Product Change Notice (PCN)

PCN Number: PCN-0451399R-01

Product(s) Affected: *PJ-063AH & PJ-063BH*

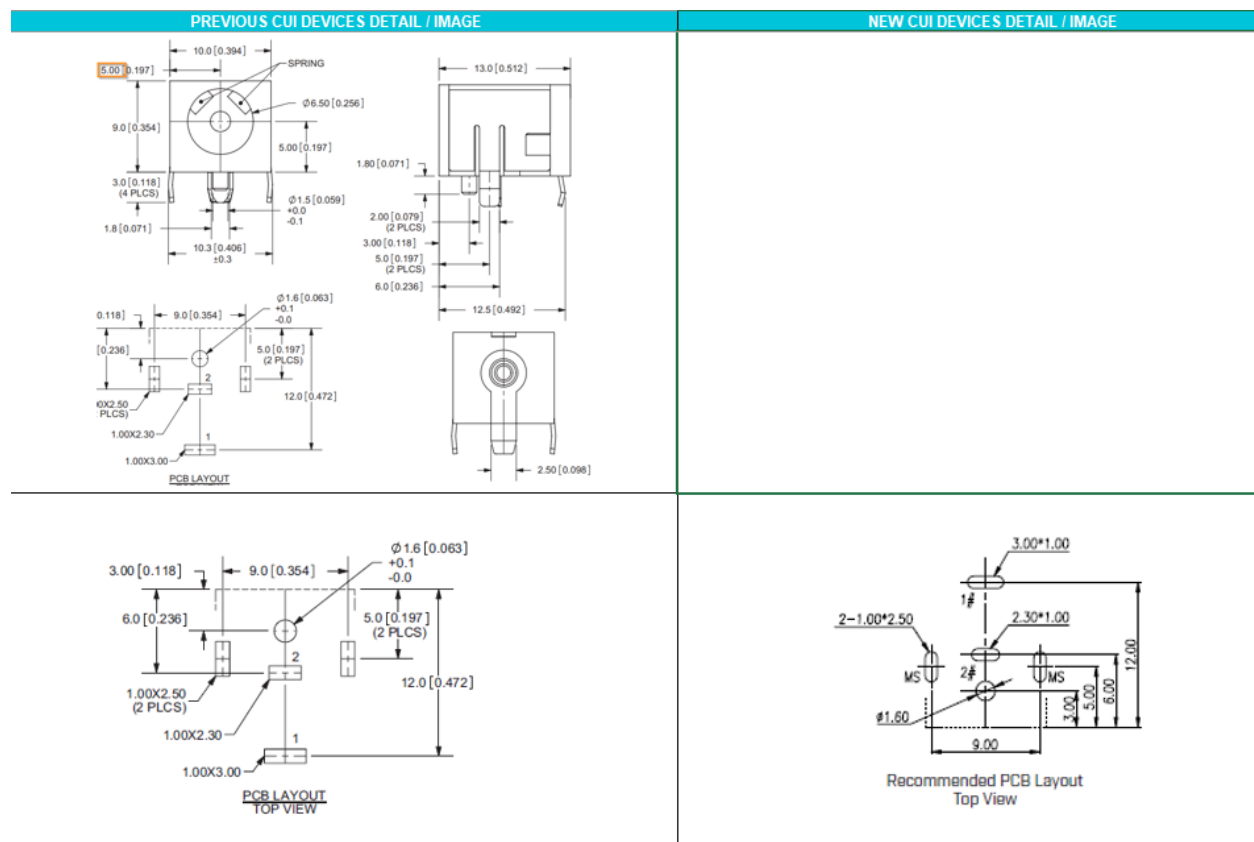
Description of Change: *Mold Change. Cosmetic differences on the mold. Stamping removed ("P" & "Made in China") All measured dimensions on the 2D drawing remain the same.*

MATING PLUG
Jack Insertion Depth: 8.85 mm

MATING PLUG
Jack Insertion Depth: 8.30 mm
